CITY OF LA GRANDE

Planning Commission Meeting

March 14, 2023

- a. Subdivision and Variance Permit
File Number: 01-SUB-23
02-VAR-23
MBM Estates, LLC

(illustration 1: Tree Planting Map)

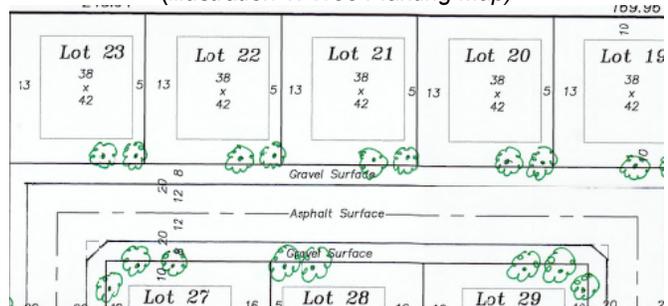
AVILA asked since the off-street parking was removed in order to put in bio-swales and comparing to surrounding developments (in the same zone) were there same issues with stormwater constraints. BOQUIST responded the code was changed a couple years ago to require the 36' wide street with two travel lanes and parking on both sides. Prior to that it was 32' with parking on one side requiring storm water drainage. The surrounding developments came in when the 32' code with parking on one side was in place and because of conflicts with 2 or 3 of those projects and people parking on both sides of the street,

MORRISON asked to see the map on how the bioswale is laid out. BOQUIST showed the tree planting map.

MORRISON commented it doesn't seem a 2nd car could be accommodated. The driveway is widened 5' wider than the 25' standard. Logan MCCRAE responded they didn't know there was a 25' standard and since then talked to the Public Works Director about the driveway and he indicated no problem.

GOUGHERTY asked about the signage and physical barriers. BROCK responded there will be signs signing off street parking at both entry points. The bioswale will be immediately off the road which should discourage parking. Also, in tree plan the trees are planted near the property line.

AVILA asked how the landscaping will be designed and the bioswale. BROCK responded in the 8' gravel space on either side of the 24' paved surface will be the bio swale and the trees will be on the property. The trees will have a concrete cur around it with bark fill. MCCRAE added they don't anticipate any run off from any other lots due to way 16th street is designed and is elevated.

(Illustration 2: footprint layout plan)

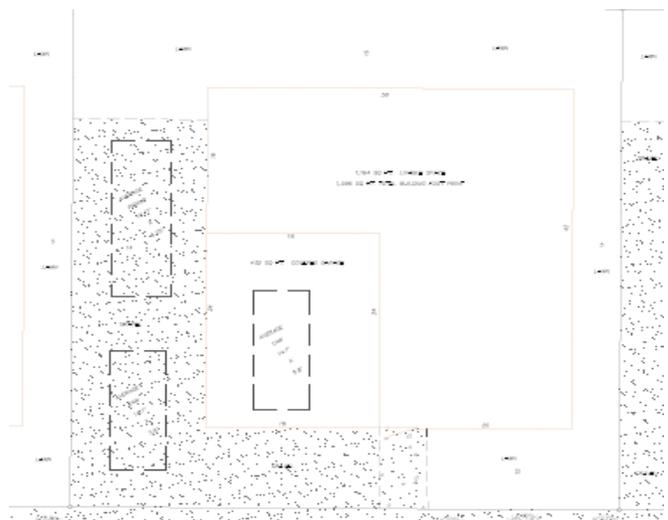
MORRISON asked to see the footprint plan which shows how the layout works.

OGILVE asked if the homes are 2- or 2-bedrooms houses. MCCRAE responded most likely see a mix in

both. The footprint plan outlines the buildable area is about 1596 sq ft, which includes about 300 sq ft for the garage and about 120 sq ft outdoor living space. The houses will either be a small 3-bedroom, 2 bath house or a big 2-bedroom, 2 bath house. OGILVIE asked for clarification on the off-street parking spots. MCCRAE asked to show the parking plan.
